Staff Report

Heritage Commission
Summary and Recommendation

Public Body: Santa Clara City Heritage Commission
Meeting Date: November 21, 2024
Current Zone: R-1-10/Historic District Overlay Zone
Property Address: Lot 4, Clara Crossing Subdivision (corner of Santa Clara Drive & Gates Lane)
Applicant Name: Neil & Michelle Walter
Staff Planner: Jim McNulty
City Staff Recommendation: Approval with conditions

Request: Walter Home #1

RIGHT ELEVATION

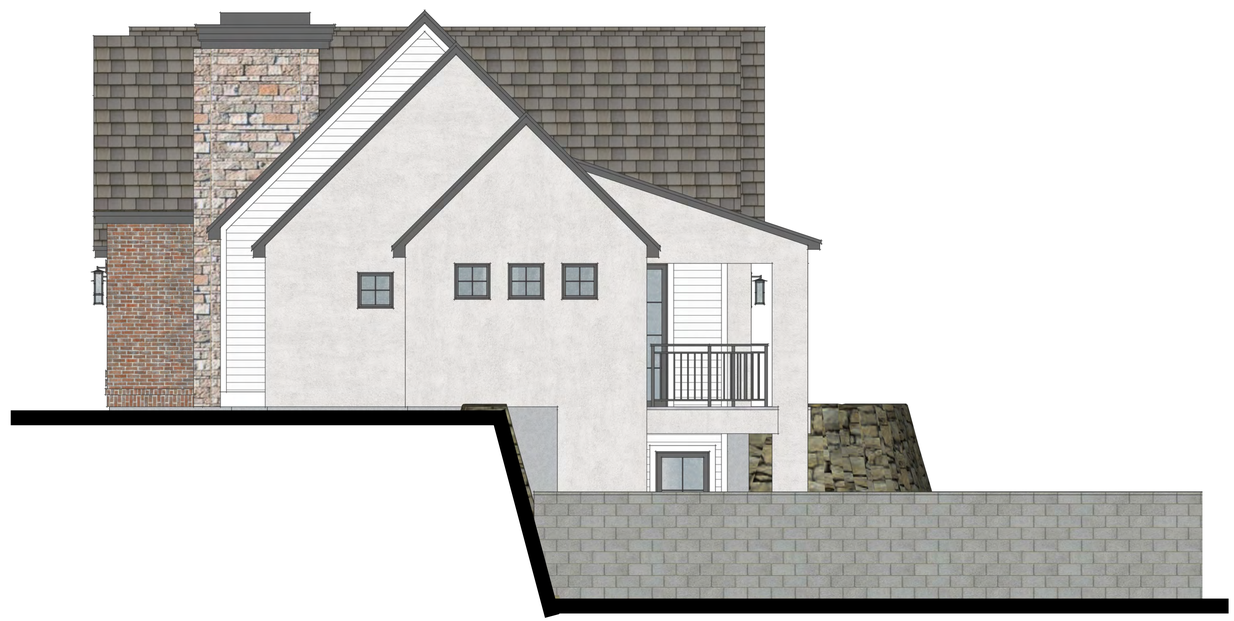
2. **Part II, Section 9 Building Materials:** Building materials shall convey texture, scale, finish, and color like those used traditionally. A minimum of 30% of the vertical wall surface should include masonry such as brick, or stone. The front and left-side elevations include brick and stone. The right-side elevation includes brick, stone, stucco and concrete, with the rear elevation mostly stucco and concrete. **It appears that the proposed building materials meet this requirement. See updated building elevations.**

Shawn recommended leaving the small windows on the west side of the home. He often puts a long, horizontal window in the owner's bedroom. However, he thought the small windows would look more historic, which is why he chose them. He added grids.
